DEVELOPMENT PLAN REPORT

FILE #: 11-I-26-DP **AGENDA ITEM #: 48**

APPLICANT:	**PERRY SMITH DEVELOPMENT**
OWNER(S):	Doug Justus Jelly Bean Properties LLC
TAX ID NUMBER:	147 109 **View map on KGIS**
JURISDICTION:	County Commission District 9
STREET ADDRESS:	0 CRENSHAW RD
LOCATION:	**North side of Crenshaw Rd, east side of Maryville Pk, south side of W Governor John Sevier Hwy**
APPX. SIZE OF TRACT:	**4.13 acres**
GROWTH POLICY PLAN:	Planned Growth Area
ACCESSIBILITY:	Access is via Crenshaw Road, an unstriped local street with 14-16 ft of pavement width within a 42-ft right-of-way.
UTILITIES:	Water Source: Knox-Chapman Utility District Sewer Source: Knox-Chapman Utility District
FIRE DISTRICT:	Rural Metro Fire
WATERSHED:	Knob Creek
ZONING:	**PR(k) (Planned Residential, with conditions) up to 8 du/ac**
PLACE TYPE:	CMU (Corridor Mixed-use)
EXISTING LAND USE:	**Agriculture/Forestry/Vacant Land**
PROPOSED USE:	**Attached residential development**
DENSITY PROPOSED:	7.75 du/ac
HISTORY OF ZONING:	In 1996 a request to extend the CA (General Business) zone across the entire property was denied (1-H-96-RZ). In 2023 the property was rezoned from CA and A (Agricultural) to PR(k) (Planned Residen

Planning
Design Guidelines
Landscape Screening

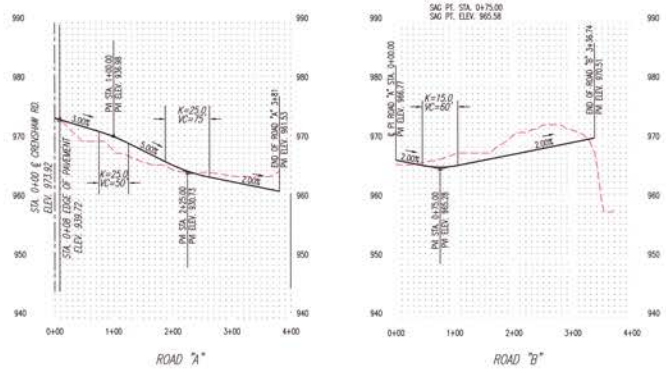
8) Provide a Type B landscape screen along the eastern boundary (Exhibit B). Existing trees that are to remain can count toward this requirement.
9) Before grading permits are issued, a landscape plan must be submitted to Planning staff for review and approval.
